UNITED STATES PATENT AND TRADEMARK OFFICE

APPLICATION NO.	FILING DATE	FIRST NAMED INVENTOR	ATTORNEY DOCKET NO.	CONFIRMATION NO.
09/681,545	04/26/2001	Dennis P. Bobay	03-DV-7090	9760

Office Action Summary

DETAILED ACTION

as shown in Figure 25.

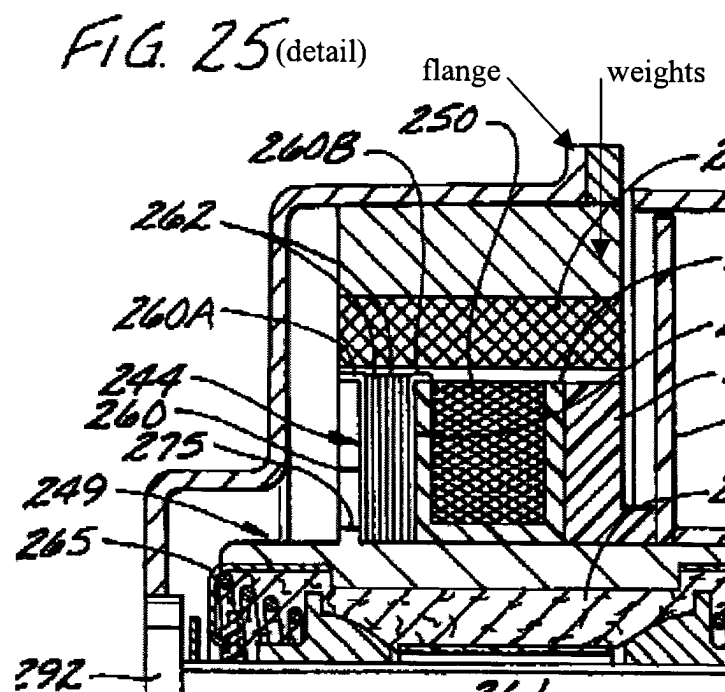
8. With regards to claim 6, 7, 9 and 10 Hollenbeck et al. discloses a rotor cup assembly, wherein:

said annular flange is configured to have an edge, said edge outwardly flared from said sidewall by an angle Φ ;

said annular flange configured to receive a plurality of weights (added by the examiner) to facilitate a desired level of rotor balance;

said annular flange second diameter greater than said housing sidewall first diameter;

said annular flange provides a smooth surface for pressing an item into said rotor cup;

12. With regards to claim 13 and 15, Hollenbeck et al. discloses a rotor cup:

configured to receive a plurality of weights (added by the examiner) to facilitate a desired level of rotor balance; and

wherein said annular flange second diameter is greater than said housing sidewall first diameter;
